**CALIFORNIA REGIONAL WATER QUALITY CONTROL BOARD  
LAHONTAN REGION**

**MEETING OF APRIL 19-20, 2017**

**WORKSHOP – DOMESTIC WASTEWATER SEWAGE TREATMENT PLANT  
STATUS IN THE LAHONTAN REGION COMMENTS RECEIVED  
AND RESPONSES PROVIDED**

Figure 1: Laurel Pond Groundwater Nitrate Levels, 2003-2016

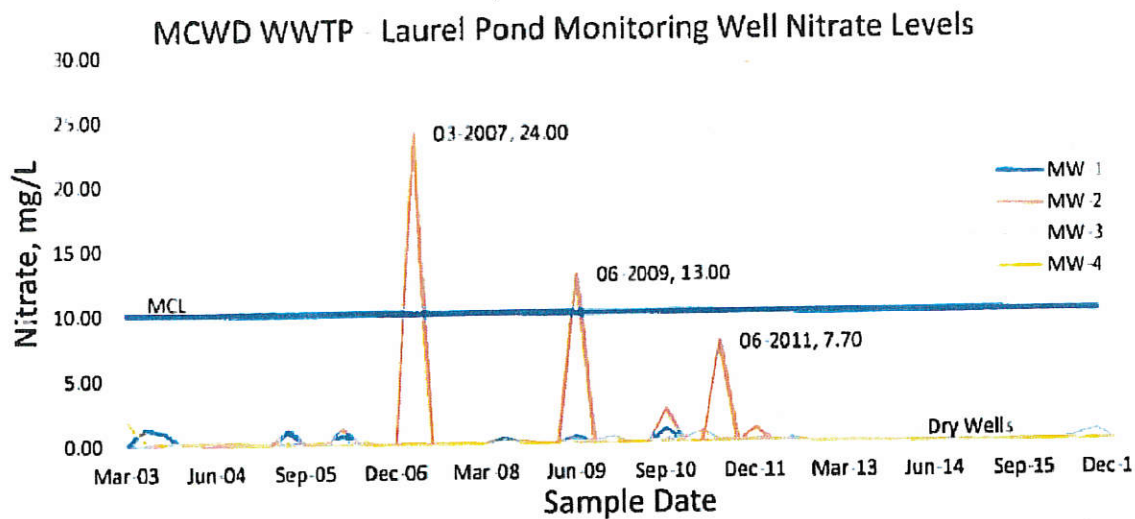
MCWD challenges the classification in the April 2017 *Staff Report on Domestic Wastewater Sewage Treatment Plants in the Lahontan Region* of our facility under the category of "both known effluent and groundwater quality over the MCL." Per the WDR, the 4 monitoring wells around Laurel Pond (MW-1 through MW-4) are sampled for nitrate on a quarterly basis. Since March 2003, quarterly monitoring have resulted in 137 "no sample result" due to a dry well and 84 samples. Analysis of these samples resulted in 40 results with less than the testing limit of 0.20 mg/L for nitrate, and an average nitrate concentration of 1.54 mg/L in the 44 samples greater than the testing limit of 0.20 mg/L. However, there are 3 distinct outlier samples as seen in Figure 1 below, occurring in March of 2007, June of 2009, and June of 2011. These outliers at MW-2 have been attributed by MCWD staff sampling notes to deceased mice or squirrels contaminating the well sample due to vandalism to the well head. The outliers drastically skew the reported nitrate groundwater levels at Laurel Pond; with the outliers removed, the average nitrate concentration of samples greater than the detection limit is 0.53 mg/L.

A known issue with the Laurel Pond monitoring wells is the difficulty in attaining samples during drought periods. The four monitoring wells are shallow at 23-25 feet below ground surface, due to hard basalt located underneath the shallow unconsolidated alluvial deposits predominately found in the Laurel Pond region (Schmidt 1996). MCWD has budgeted this fiscal year to contract with Wildermuth Environmental hydrogeological consultants to prepare specifications for the replacement of the Laurel Pond groundwater monitoring wells. The replacement wells will be designed to be more secure and penetrate the top 30 feet of basalt underlying the alluvium. Draft specifications will be submitted to permitting agencies for approval to construct the new wells and properly abandon the existing wells. Following high runoff periods, more monitoring well samples have been able to be taken. Two successful samples were taken from MW-3 in June and September of 2016 following a 3 year period of all wells being too dry to take samples. MCWD anticipates additional samples will be able to taken this year after anticipated (near) record runoff, which will aid in monitoring for compliance with the WDR.

**Response:** The information on groundwater nitrate concentration results adjacent to Laurel Pond was informative. It does appear that overall nitrate concentrations are generally low, followed by an extended recent period where the wells were dry due to the drought. It will be useful to review data from this year as the groundwater elevations may rise somewhat. It isn't clear how deceased rodents would have contributed to the elevated historical groundwater nitrate concentrations observed over the drinking water objective of 10 mg/L nitrate-nitrate in 2006 and in 2009. However, you rightfully indicate that vandalism can be a problem in keeping the well heads secure in a remote location. Your letter indicates that you intend to install some additional deeper wells in the near future. Please ensure that we receive the Work Plan for new well installations, signed by a CA registered professional geologist, showing the proposed well locations and construction design.
